Accessibility Audit Report

Khulna BNSB Eye Hospital, Phultala, Khulna

October 10, 2021

Pic-2: Pathway does not have any tactile ground surface indicators

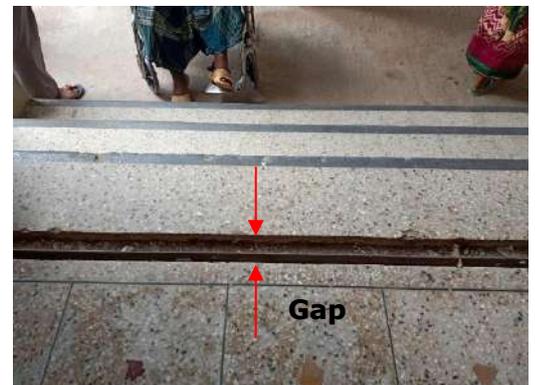
The pathway is wide enough, flat, concrete, non-slippery, obstacles, and hazards free for users of all abilities to move along to get to the main entrance of the building. However, no tactile ground surface indicators are present on the pathway leading to the entrance of the reception and main building (Pic-2).

2) Installing tactile ground surface indicators on the pathway (pic-9).

Pic-10: Different gradients of the ramp.

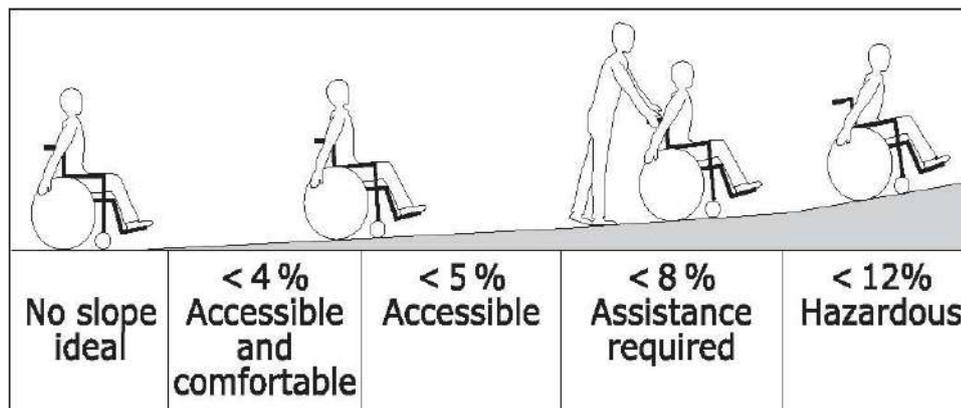
There is three entrance gate alongside the main entrance which have three steps to enter the hospital building. The width of each gate is 3480 mm wide. The height of each step/stair is 152 mm high and 305 mm deep. The pathway in front of the entrance is 4572 mm wide. The edge of the stairs is covered with metal which is in contrast in color with stairs. There is no ramp at the entrance. So that elderly person, persons with disabilities, pregnant women, etc. face difficulties during accessing eye care services (Pic-3).

3) A straight run ramp at the first entrance gate (Pic-10)

- A straight run ramp (minimum of 3480mmx2096mm platform along with a 5486mm long slope) is recommended at the first entrance gate (Annexure-1). The width of the slope will be 1524mm. Ensure the ramp has a maximum gradient of 1:12 ratio. The 1:12 gradient (Pic-10) will allow wheelchair users to propel their chairs independently on the ramp. The bottom landing of the ramp should be 2096mmx1524mm free space. This will allow the wheelchair user to full turns.

Pic-40: Proposed space for accessible toilet

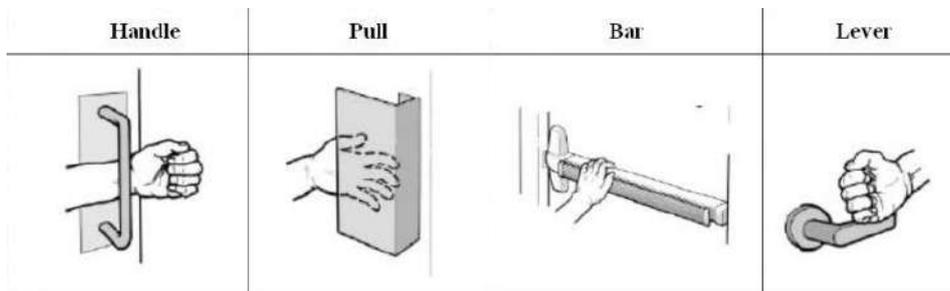
It is highly recommended to build at least one accessible toilet on the ground floor and for other floors including ward in separated male and female signage. There is a store room next to room no. 11. This room can be converted to an accessible toilet for the ground floor. The existing dimension is enough to build a such toilet. And this will require civil works.

1. The existing room dimension is 3531mm x 2896mm which is bigger than the ideal room dimension of an accessible toilet.
2. The door has a threshold and must be removed for wheelchair access.
3. Clear directional signage indicating the location of the toilet/accessible toilet.
4. The door should have-
 - a) Clear opening width of 900mm;
 - b) A clear space on both sides of the door that allows a wheelchair to approach the door and open it;
